SUMMARY OF CONCERNS IN RELATION TO THE PROPOSED NORTHCONNEX TUNNEL

This is an objection to many aspects of the proposed NorthConnex tunnel.

SECTION A: THE CONNECTIVITY OF NORTHCONNEX SOUTHERN VENTILATION FACILITY AT THE SOUTHERN INTERCHANGE, THE SOUTHBOUND TUNNEL IN PARTICULAR

Figure 5-17 Motorway operations complex

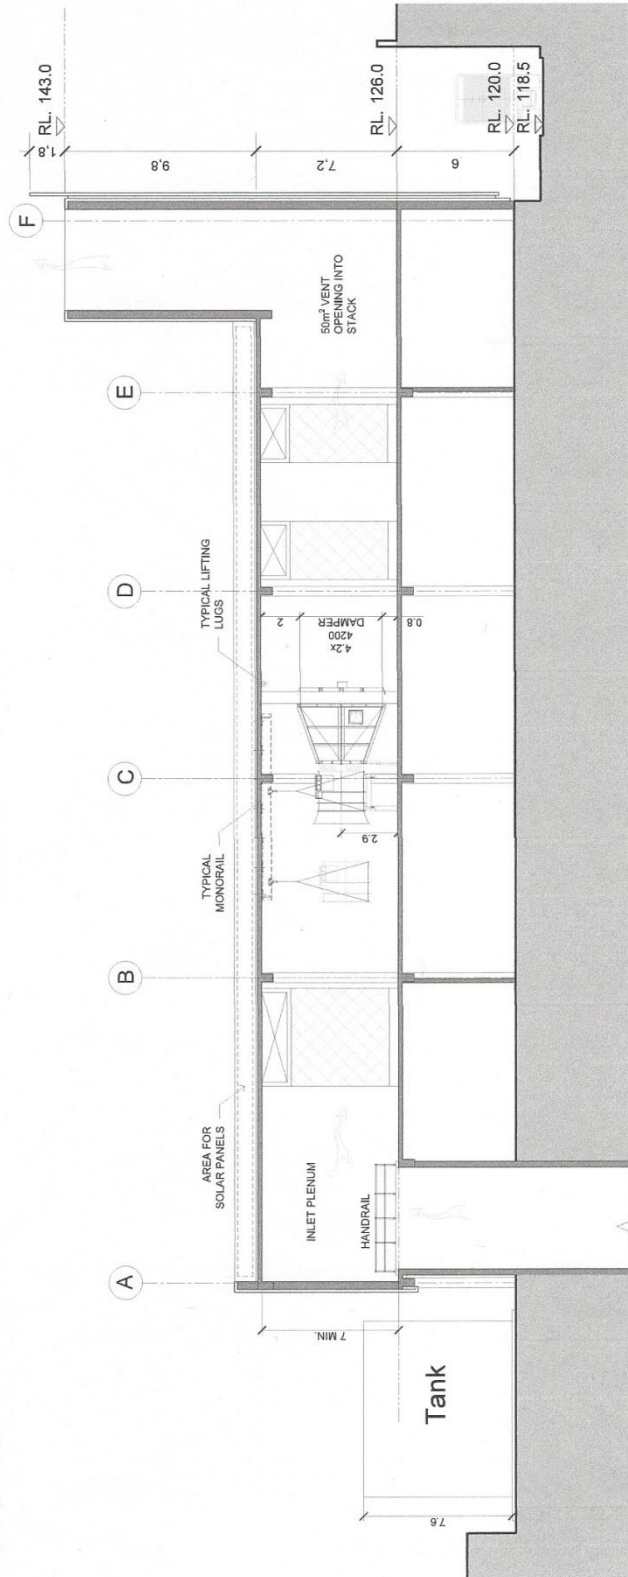
EIS Page 111, *Figure 5-17 Motorway operations complex*

Page 8 below there is no indication of how the ventilation facility will be connected to either the northbound or southbound tunnel, nor is there any indication of how the southbound exit portal onto Pennant Hills Road or the south-west exit portal onto the M2 will be connected.

In each of the above figures for Wilson Road, Trelawney Street, and Northern Ventilation facility, the shafts, emergency smoke extraction buildings, and ventilation facility make a substantial footprint in the construction area; however for the Southern Interchange the ventilation facility is an insignificant part of the construction area. How can this be? The difference in scale does not explain the difference.

We also find it disturbing that in each of the above figures for Wilson Road, Trelawney Street, and Northern Ventilation facility the headings are for “*tunnel support facility operational layout*” and “*ventilation facility operational layout*” but for the Southern Interchange the description is for “*Motorway operations complex*” with no mention of the ventilation facility or the tunnels.

MOTORWAY OPERATIONS COMPLEX - SOUTHERN VENTILATION FACILITY - SECTIONS
M1-M2-5000-DR-JD-0525

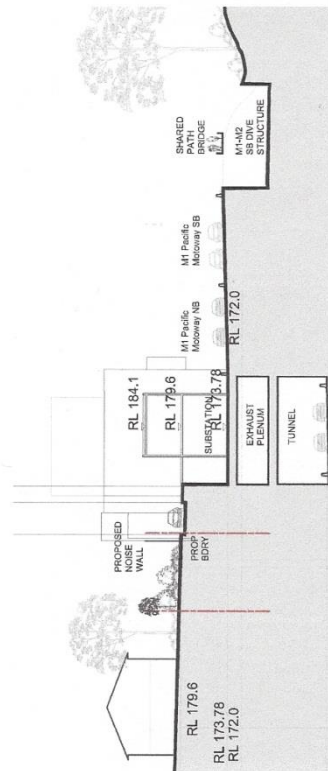
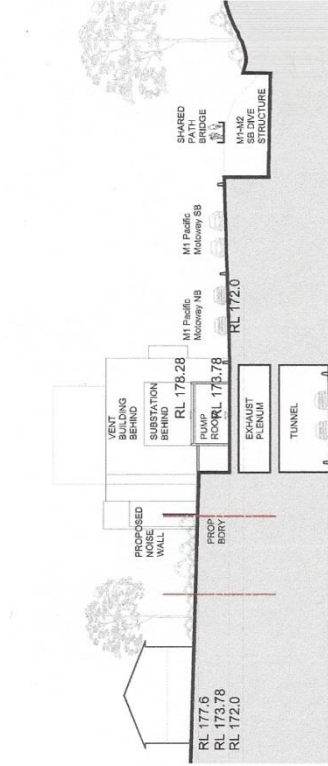
5. *EIS Volume 4, Technical working papers - Urban Design, 6.0 Operational Ancillary Facilities*
EIS Page 99 there is the diagram "Motorway Operations Complex – Southern Ventilation Facility – sections. *Page 10 below* The diagram has the cryptic label "Connection to tunnel TBC". What does TBC stand for? To be considered? Why is tunnel singular? Which tunnel is the diagram referring to northbound or southbound? There is no diagram showing any connection from the Southern Interchange ventilation facility to either the northbound or the southbound tunnel in any way
AND YET

- Diagrams need to be provided showing the inter-relation between the shaft, the ventilation outlet and the motorway operations centre with a clear description of what is to be constructed and how it will operate.
- The community needs irrefutable evidence that the polluted air from the southbound tunnel exit portals will not be allowed to flow like an invisible sewer through West Pennant Hills, North Rocks, Carlingford and Beecroft.

M1-M2-5000-DR-UD-0550
NORTHERN VENTILATION FACILITY - CROSS SECTIONS

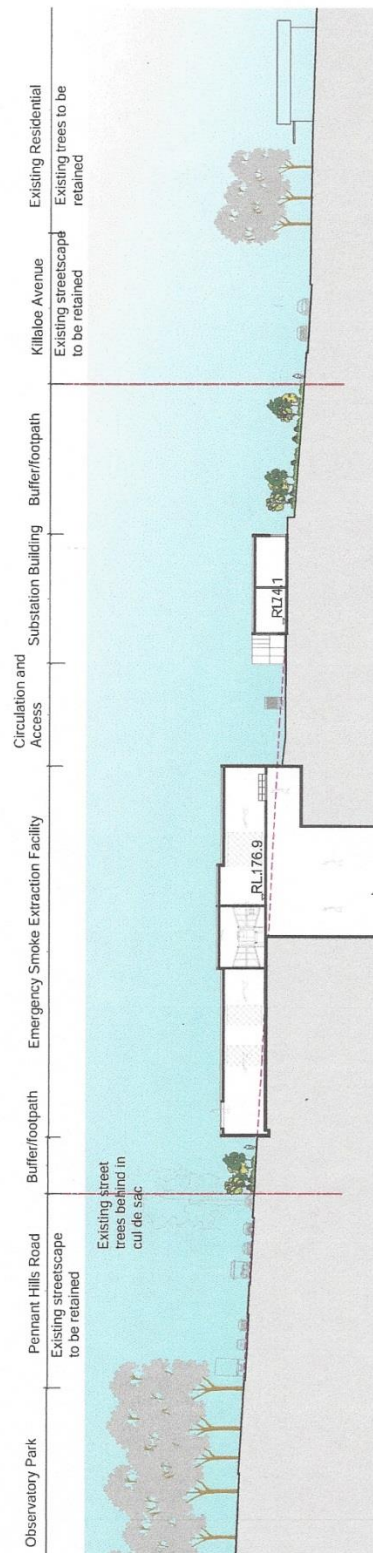
EIS page 135 *Page 11 below* there is a very explicit diagram showing the *Northern Ventilation Facility – cross section*.

Why are there no comparable diagrams for the Southern Interchange and the Southern Ventilation facility?
